USB ENGINEERING CHANGE NOTICE

Title: HSIC ECN

Applies to: High Speed Inter Chip Specification, Rev 1.0

3 Data Signaling Text Additions

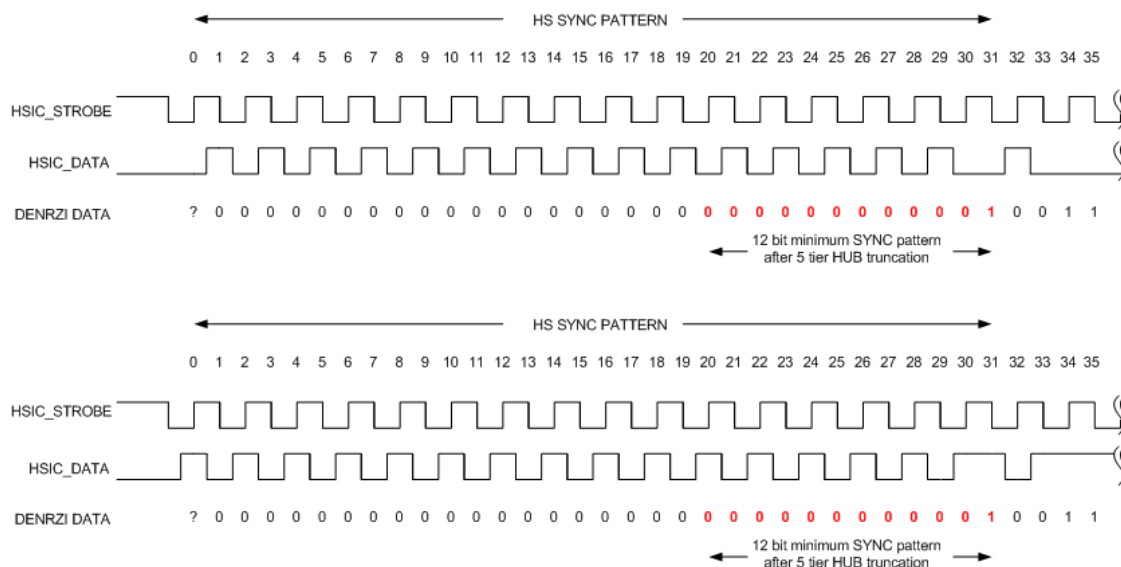
The following text additions to the High Speed Inter Chip Specification, section 3.4 Data Signaling:(the existing text in section 3.4 remains, the text below is added as supplemental information after the existing text)

The HSIC receiver should be designed to be adaptive, meaning that the HSIC receiver does not filter packets based on a USB “J” or USB “K” encoding, but instead uses the decoded NRZI (DENRZI) and unstuffed data (the raw data). Please see the example below showing SYNC packet encoding and inverted encoding, and how the raw data is identical.

Example: The first pattern is an HSIC data pattern of (0101...0100). The second SYNC pattern is (1010...1011), the inverse of the previous pattern. In both cases the resulting raw data (DENRZI) is identical (0000...0001) which is a valid USB SYNC in both cases.

Reason: The adaptive receiver recommendation is that many USB PHYs are designed to qualify USB packets based on the DENRZI unstuffed data and the encoded repeater path data may not meet the above listed encoding requirements. Additionally, this will ensure that receivers maintain backward compatibility with any existing legacy HSIC devices that may transmit inverted data
